Access Compliance Report

Public Rights-of-Way

(Curb Ramps)

Intersection ID: 25628	Main Street: WINDSWEPT_DR	Cross Street: PINEVILLE-MATTHEWS_RD	Location: E
ADA ID: 6FFB8306B137	Ramp Type: Perp	Initial Pass/Fail: Fail	Overall Compliance: No
		Severity Score: 1.25

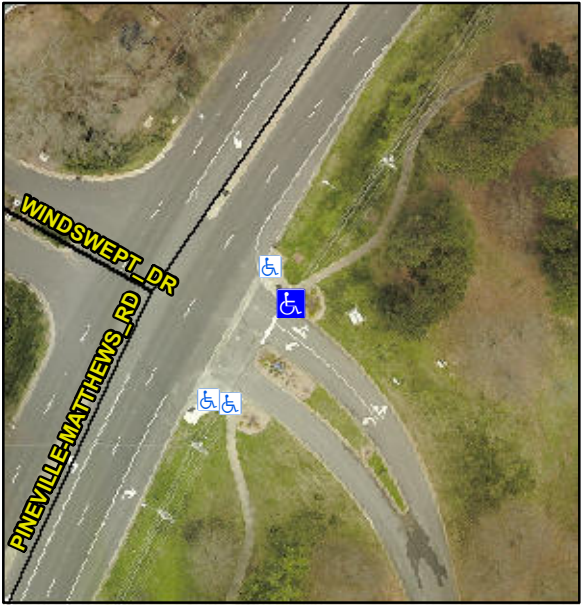
Codes/Mitigation Info/Possible Solution			Field Measurements/Component Compliance		
	Possible Solutions:		Compliance	Description	Data
	Remove & Replace Entire Ramp.		Yes	Ramp Length (in)	83.0
			N/A	Ramp Width (in)	51.0
			N/A	Flare Type LT	N/A
			N/A	Flare Slope LT (%)	N/A
			N/A	Flare Traversable LT?	N/A
			N/A	Flare Type RT	N/A
			N/A	Flare Slope RT (%)	N/A
			N/A	Flare Traversable RT?	N/A
			N/A	DWS Provided?	N/A
<p>Surveyor Notes:</p> <p>N/A</p>			N/A	DWS Contrast?	N/A
			N/A	DWS Length (in)	N/A
			N/A	DWS Full Width?	N/A
			N/A	DWS Offset (in)	N/A
			N/A	Shared Landing?	N/A
			N/A	Gutter Ponding?	N/A
			N/A	Gutter Lip Ht (in)	N/A
			N/A	Painted X Walk1?	No
			N/A	X Walk 1 Direction	To SW
			N/A	X Walk 1 Width (in)	N/A
<p>PROW/ADA:</p> <p>Not Found, R304.5.3</p>			N/A	X Walk 1 Slope (%)	0.1
			N/A	X Walk 1 X Slope (%)	3.6
			N/A	Ramp inside XWalk1?	N/A
			N/A	Ramp inside XWalk2?	N/A
			N/A	Road Slope (%)	N/A

N/A	Road X Slope (%)	N/A
			N/A	Clear Space?	N/A
			N/A	Clear Space to XWalk (in)	N/A
			N/A	Storm Grate/Utility Hazard?	N/A
			N/A	Storm Grate/Utility Type	N/A
<p>Total Cost:</p> <p>\$ 1850.00</p>			N/A	Obstruction Type	N/A
			Yes	Surface Condition? (G/P)	Good
